IMPORTANT SAFETY RECALL

NHTSA Recall # 26V-342

Tiffin Recall # WAY-107

Incorrect Occupant and Cargo Carrying Capacity Label Color

Figure 1

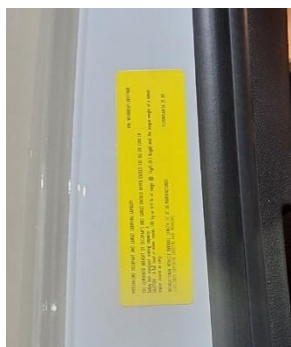
Certain motorhomes do not have the correct label color for the Occupant and Cargo Carrying Capacity (OCCC) label. Incorrect colors for the labels in the motorhome may lead to difficulties in locating the correct information for loading and tire pressure which could increase the risk of a crash.

Tiffin Motorhomes will replace the incorrectly colored label with a label that is the correct color of yellow. To correct this issue, we are sending owners a corrected Occupant and Cargo Carrying Capacity Label to be placed in your motorhome (enclosed).

1. The incorrect white OCCC Label can be found on the driver's side door panel. The label should be left in the current position.
2. Wipe a clear area of the passenger side door jamb with isopropyl alcohol.
3. Carefully install the new label on the cleaned area of the passenger side door jamb. DO NOT cover up the existing yellow label already installed in the passenger side door jamb as it contains different important information.
